October 15, 2014

Re: Hydro One Networks Inc. 2015-2019 Distribution Rate Application
AMPCO's Final Submissions
Board File No. EB-2013-0416

Adam White
President
Association of Major Power Consumers in Ontario

Figure 4: Failures of Station Transformers

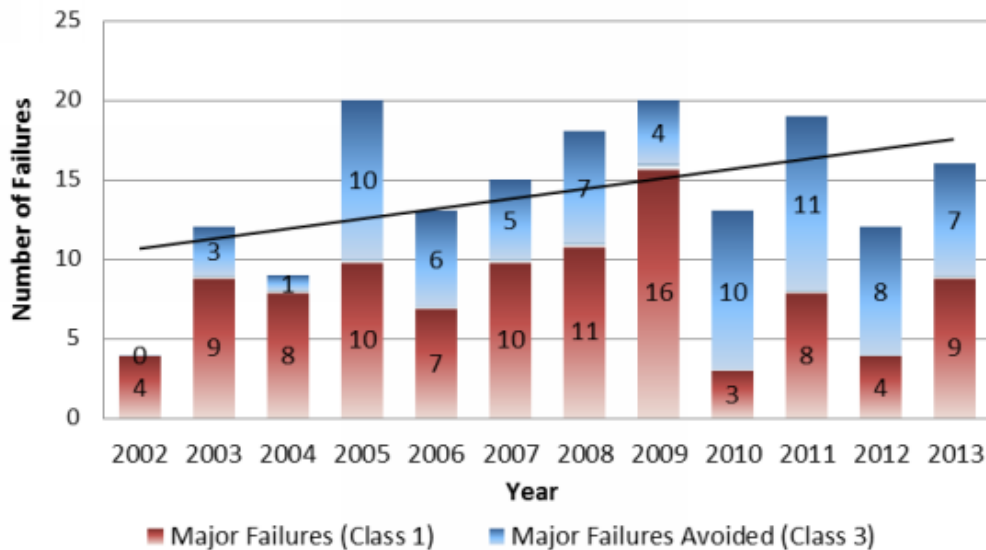
Hydro One indicates the number of major transformer failures combined with number of major failures avoided from 2002 to 2013 has been trending higher. AMPCO submits when the number of major failures avoided by proactively removing transformers from service data is excluded from the analysis, the number of major failures is actually trending lower since 2009.⁵²

AMPCO submits the failure data in this application differs from the failure data provided in EB-2009-0096. In EB-2009-0096 Hydro One explained that it has continued to focus on maintenance and diagnostic activities regarding transformers and has demonstrated that investments are well directed based on the reduction in transformer failures over the 2004 to 2008 period from 37 in 2004 to 21 in 2008. AMPCO notes the number of major avoided failures has not been identified as being included in this failure data. Hydro One further indicates in EB-2009-0096 that its OM& A and Capital programs provide appropriate funds to effectively manage the life cycle of these assets and will address those identified to be at high risk over the next 5-years to 2013.⁵³ AMPCO submits the asset management strategy for transformers has shifted significantly since EB-2009-0096 and the failure data is not consistent. AMPCO submits that Hydro One's rationale for increased expenditures in the test period is based in part on the failure rate trend which AMPCO submits shows a decline and does not justify the significant ramp up in expenditures.

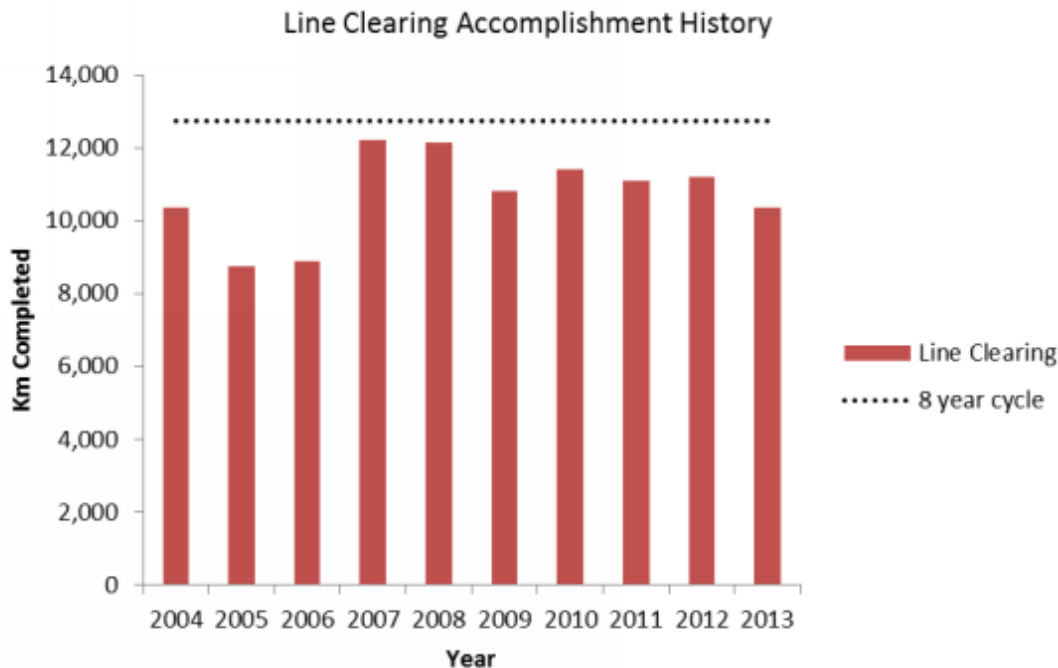
Hydro One forecasts expenditures in its Vegetation Management Program of \$814 million for the test years 2015 to 2019 to meet the outcome targets (discussed below) which is a 22% increase over the 2010 to 2014 spend of \$668 M.⁸¹ The two tables below show Hydro One's historical and proposed spending on vegetation management.

In order to improve the life cycle costs of the vegetation management program, Hydro One proposes increases in vegetation management OM&A on average 25% annually over the 2016-2017 period to 14,250 km annually in order to return the line clearing work program to 12,750 km annually, which will sustain the 8-year cycle target. Hydro One predicts that by 2018 and 2019, the crest of the backlog wave will have been addressed and Hydro will begin to realize the cost benefits of returning feeders on cycle which is reflected in the declining spending levels for those years and will drive the overall cost of the work program down to a level that is cost efficient and sustainable for the long run.⁸⁵

Fig. R6 Line Clearing & Brush Control Costs per Kilometre for 2006-2008

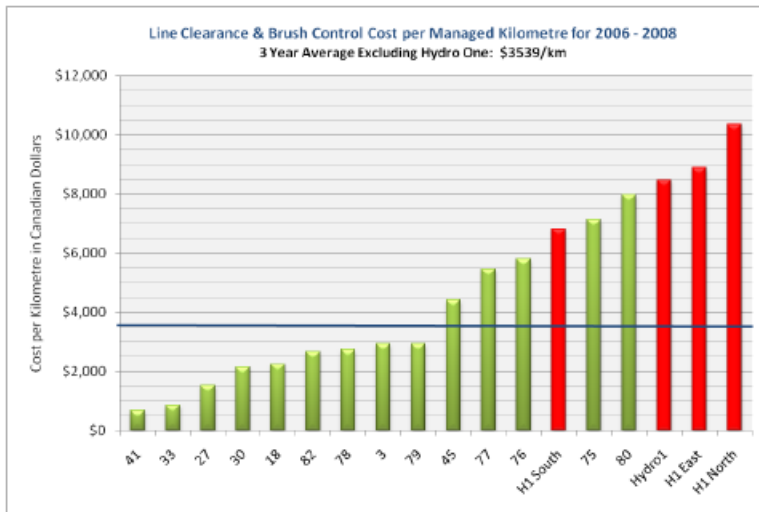
AMPCO submits that Hydro One's increasing cost issue is not founded in the proposed accomplishments, but in poor and declining productivity over time. The EB-2009-0096 Vegetation Management Benchmarking Study revealed poor productivity at that time as shown in the Table below from the Study.⁸⁶ In AMPCO's view, the Vegetation Management Study shows that the actual per unit cost for Hydro One to treat a tree was more than double that of other utilities.

As shown in the charts provided in K5.1 Pages 50-52, Hydro One's has an increasing trend of poor productivity related to vegetation management, specifically related to line clearing and brush control. The highest unit costs are in 2014 and 2015. Cost efficiency related to vegetation management has been an issue in past Hydro One proceedings. AMPCO submits Hydro One's escalating and unsustainable unit costs are preventing it from getting its clearing cycle to an 8 year cycle.
